Access Compliance Report

Public Rights-of-Way

(Curb Ramps)

Intersection ID: 27452	Main Street: BALLANTYNE_COMMONS_PY	Cross Street: BALLANTYNE_CORPORATE_PL	Location: NW
ADA ID: FDF50F9732DF	Ramp Type: Directional1	Initial Pass/Fail: Pass	Overall Compliance: No
Severity Score: 2.75			
Codes/Mitigation Info/Possible Solution		Field Measurements/Component Compliance

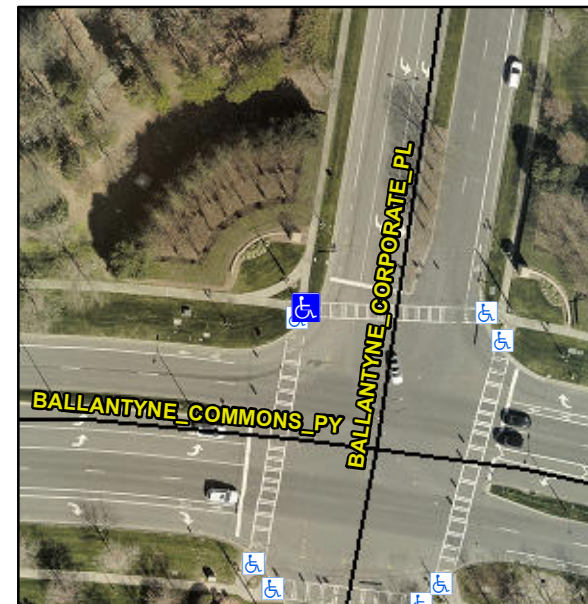
**R304.2.2-Perp, R304.3.2-Para,
R304.5.3, R305.1.4**

Compliance	Description	Data	Compliance	Description	Data
N/A	Ramp Length (in)	23.0	N/A	Grade Break?	N/A
Yes	Ramp Width (in)	57.0	N/A	Grade Break Slope (%)	0.0
Yes	Ramp Slope (%)	1.0	N/A	Grade Break XSlope (%)	0.0
Yes	Ramp XSlope (%)	2.5			
Yes	Flare Type LT	N/A	Yes	Flare Type RT	N/A
N/A	Flare Slope LT (%)	N/A	N/A	Flare Slope RT (%)	N/A
N/A	Flare Traversable LT?	No	N/A	Flare Traversable RT?	No
Yes	Landing Length (in)	62.0	Yes	DWS Provided?	Yes
Yes	Landing Width (in)	72.0	Yes	DWS Contrast?	Yes
No	Landing Slope (%)	2.4	Yes	DWS Length (in)	26.0
No	Landing X Slope (%)	3.0	No	DWS Full Width?	No
N/A	Landing Curb? (Y/N)	No	Yes	DWS Offset LT (in)	0.0
N/A	Shared Landing?	Yes	Yes	DWS Offset RT (in)	0.0
Yes	Gutter Ponding?	No	Yes	Gutter Slope (%)	3.1
Yes	Gutter Lip Ht (in)	0.0	No	Gutter X Slope (%)	4.6
N/A	Painted X Walk1?	Yes		Road Slope (%)	2.4
	X Walk 1 Direction	To E		Road X Slope (%)	2.9
	X Walk 1 Width (in)	99.0		Clear Space?	Yes

**Remove & Replace Entire Ramp.
Remove & Replace Gutter.**
